Flight Procedures Cover Page	Task Action: FLIGHT CHECK	Task Type: SID	Estimated Chart Date: 09/03/2026	APWS Task ID: ABFFC571D3A54CF191D68F8CF7D59A74	APWS Project ID: 7E36E542A7DD45EA9280F90A152F748D
Procedure: HUDAD THREE DEPARTURE (RNAV)		Enroute: YES	Specialist: Palmer, Leo		Agreement Number:
Airport ID: KDFW			Airport City: DALLAS-FORT WORTH		State: TX
Facility ID:	Facility Type:	Flight Inspection Remark Type: New FC Slot

FIPC DME/DME FORM						
PROCEDURE: HUDAD THREE DEPARTURE (RNAV)			AIRPORT NAME: DALLAS-FORT WORTH INTL		AIRPORT ID: KDFW	SPECIAL CONTROL NO: OG-03-147-26
FAC ID: HUDAD3		CITY: DALLAS-FORT WORTH			ST: TX	ORIG CHART DATE: 09/03/2026
DFL TYPE: PROC/D	THIRD PARTY: ☐ YES	EST. TIME ON SITE: 1.0	REIMB. NUMBER:	PTS TASK ID: ABFFC571D3A54CF191D68F8CF7D59A74		
PREFLIGHT NOTES						
REVIEWER:					DATE:	
COMMENTS:					CHECK ONE: ☐ FLT CK REQ ☐ NFCR ☐ REJECT	
					YES	NO
					CPV COMPLETE? ☒ X ☐	
PROCEDURE RESULTS						
INSPECTION DATE: 04/03/2026	CREW #: VN282	N #:	INSTRUMENT PROCEDURE STATUS: ☒ SAT ☐ SAT W/CHANGES ☐ UNSAT		ARINC CODING: ☒ SAT ☐ SAT/GOLD ☐ UNSAT	
FLIGHT INSPECTOR SIGNATURE: james krenek @ 04/06/2026 10:03			PRINTED NAME: KRENEK, JAMES LEROY			NOTAM INITI

(HUDDAD3.HUDDAD) FIG

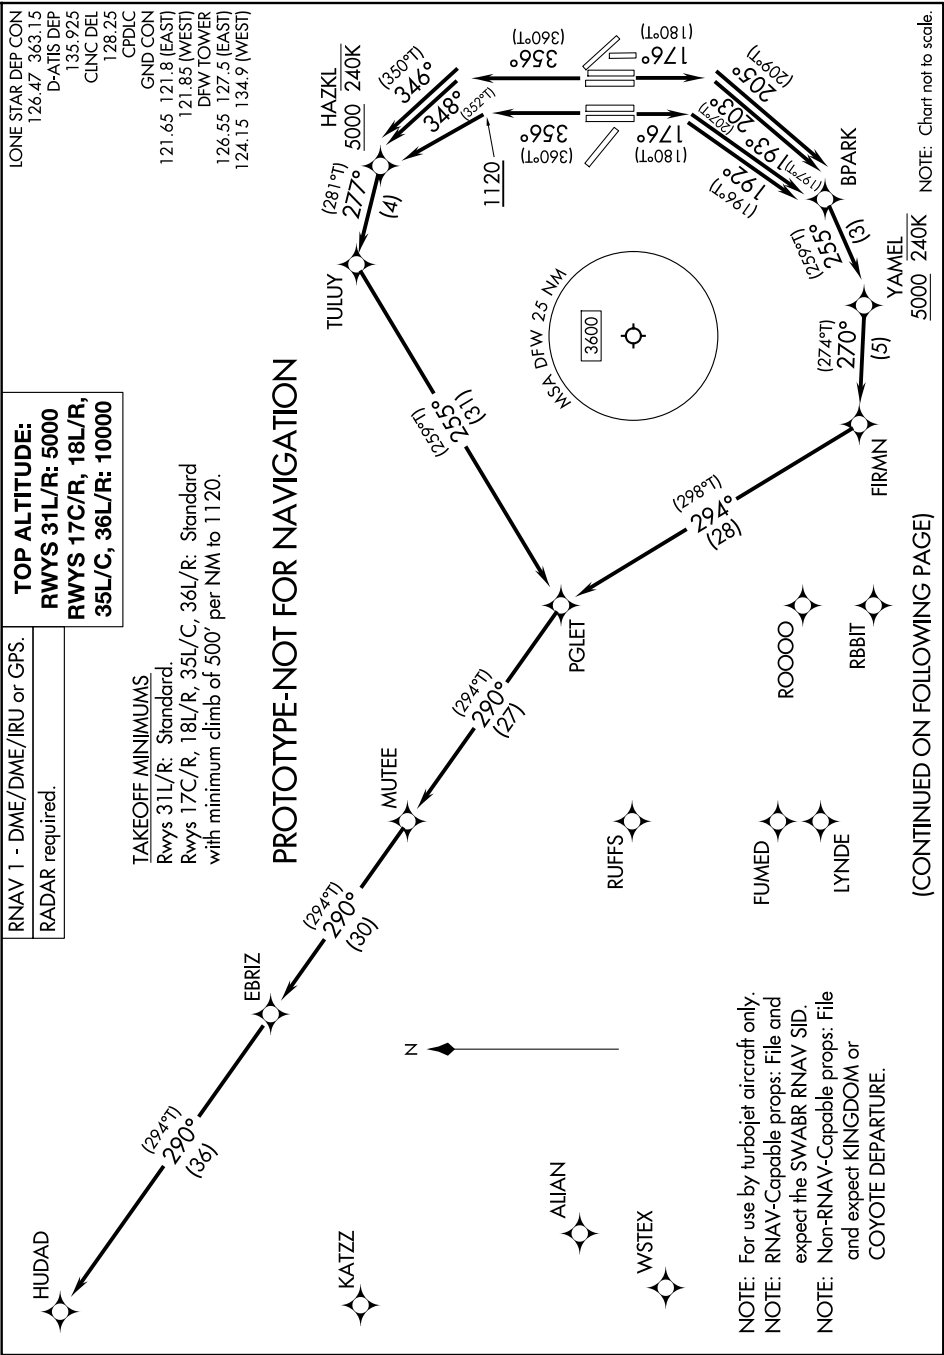
08/14/25: THIS IS AN UPDATED COPY OF THE FORM DEVELOPED ON 5/23/25.
1. DP ROUTE DESCRIPTION: RWY 17C, 17R, 18L, 18R, 35C, 35L, 36L, 36R, REMOVED RUNWAY TRANSITION DESCRIPTION AFTER FIRST TF LEGS, YAMEL AND HAZKL - PER AFS.

2. COMMON ROUTE: RWY 17C, 17R, 18L, 18R, 35C, 35L, 36L, 36R, REMOVED COMMON ROUTE DESCRIPTION AND REPLACED WITH "THEN ON DEPICTED ROUTE TO HUDAD" - PER AFS.

3. COMMON ROUTE: RWY 31L/R, REMOVED COMMON ROUTE DESCRIPTION AND REPLACED WITH "THEN ON DEPICTED ROUTE TO HUDAD" - PER AFS.
4. PROCEDURAL DATA NOTES: REMOVED "NOTE: RNAV-CAPABLE PROPS: FILE AND EXPECT THE SWABR RNAV SID.", "NOTE: NON-RNAV-CAPABLE PROPS: FILE AND EXPECT KINGDOM OR COYOTE DEPARTURE."-
PROCEDURE DESIGNATED FOR USE BY TURBOJETS. - PER AFS.

2/26/26: THIS AN UPDATED COPY OF THE FORM DEVELOPED ON 5/23/25
1. RWY 31 L/R DEPARTURE ROUTE DESCRIPTION AND CODING CHANGED FROM "CLIMB HEADING ASSIGNED BY ATC, FOR VECTORS TO PGLET, THENCE..." TO "TAKEOFF RWY 31L: CLIMB ON HEADING 315.06
TO 1109, FOR VECTORS TO PGLET, THENCE...." AND "TAKEOFF RWY 31R: CLIMB ON HEADING 311.28 TO 1109, FOR VECTORS TO PGLET, THENCE...." 8260.15C CODING CHANGED FROM VM/DF TO VA/VM. - PER AFS -
IAW 8260.46K 3-1-6 B (3).
2. REMARKS: ADDED WAIVER ON FILE FOR ATC REQUESTED MAINTAINED ALTITUDE LOWER THAN THE UNRESTRICTED CLIMB ALLOWED BY TERPS EVALUATION", - ADDITIONAL WAIVER REQUIRED PER AFS.
3. REMARKS: REMOVED "WAIVER ON FILE FOR TERMINOLOGY USED IN DP ROUTE DESCRIPTION FOR RWY 31L/R (CLIMB HEADING ASSIGNED BY ATC)." - PER AFS NO LONGER REQUIRED, SUPPORTED BY CRITERIA.
